Washer Fluid Reservoir Rattles While Driving on Rough Roads

This Service Information bulletin replaces SI B61 06 15 dated **March 2015**.

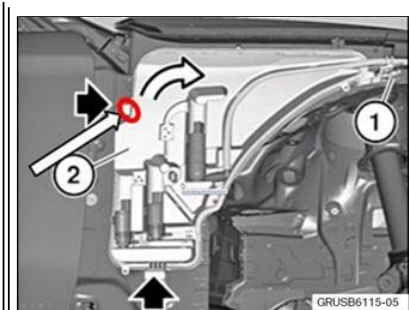
The windshield washer reservoir upper plastic locating guide tab has too much lateral play.

Note: The close-up picture shows a gap (0.40 mm) that exists between the plastic reservoir guide and the metal securing bracket.

Apply a piece of self-adhesive felt tape to the upper plastic locating guide of the washer fluid reservoir.

6. With the reservoir removed, clean the upper guide tab with a clean cloth.
7. Prepare a piece of felt tape (80 x 60 x 1 mm) and apply it to the guide tab in the area shown.

The felt tape will eliminate the rattling noises coming from the metal bracket which can transmit into the glove compartment area.
